U. S. NUCLEAR REGULATORY COMMISSION
REGION IV

Dockets: 50-313/82-12
50-368/82-25

Facility Name: Arkansas Nuclear One (ANO), Units 1 and 2

Inspection conducted during the period of May 24-27, 1982
(Reports 50-313/82-12 and 50-368/82-25)

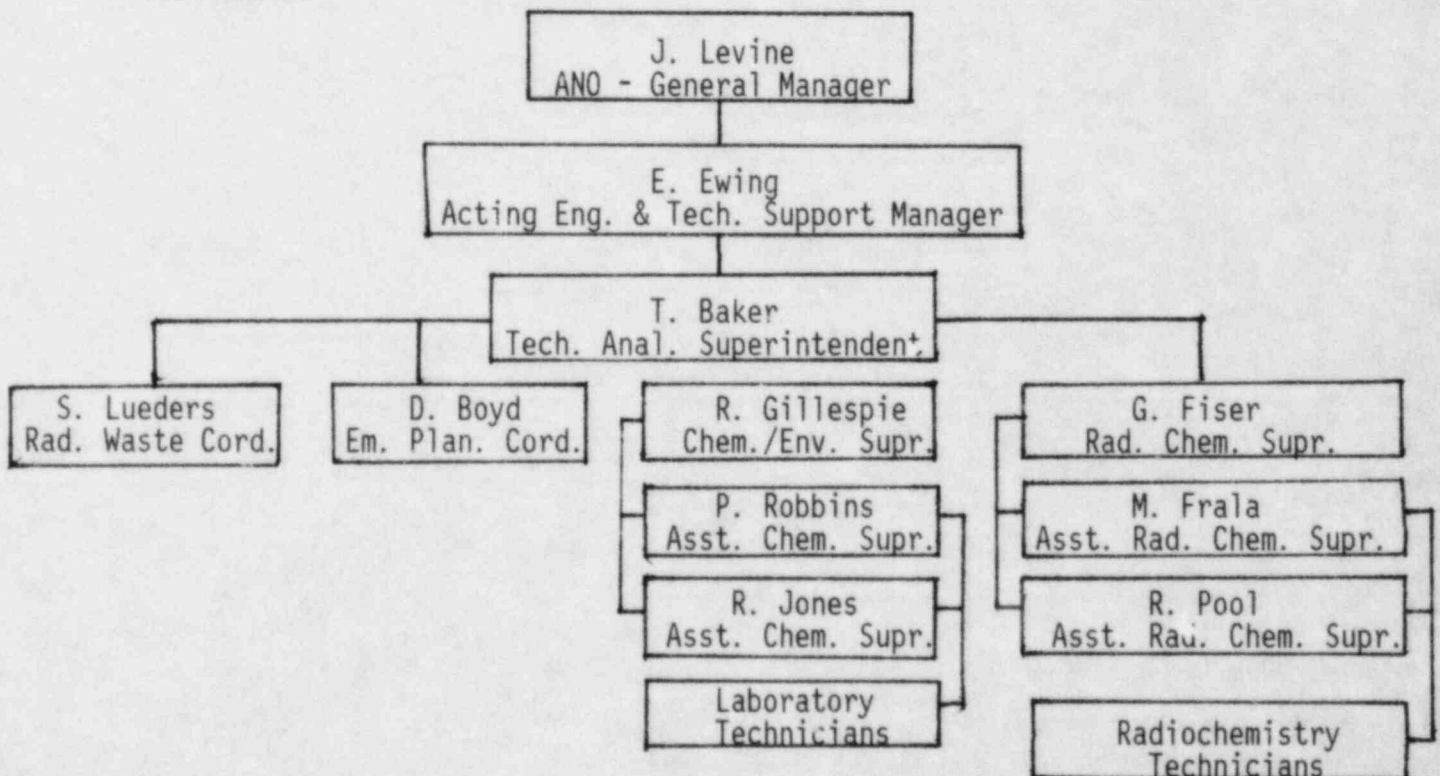
The NRC inspector reviewed the Arkansas Nuclear One plant staff assignments in regard to chemistry and radiochemistry responsibilities. The following diagram shows the present structure and assigned individuals:

The NRC inspector is concerned regarding the present onsite management organization, in that job/position descriptions, staff qualification requirements, and implementing procedures for functional area assignments have not been developed.

Job/position descriptions had not been developed which detail the duties and responsibilities of members of the radiochemistry staff. A job description for the Radiochemistry Supervisor had been completed. However, similar job descriptions for other staff positions had not been established.

This item is considered open (313/8212)/(368/8225)-(01) pending issuance of radiochemistry staff job descriptions and implementing procedures governing functional area assignments.
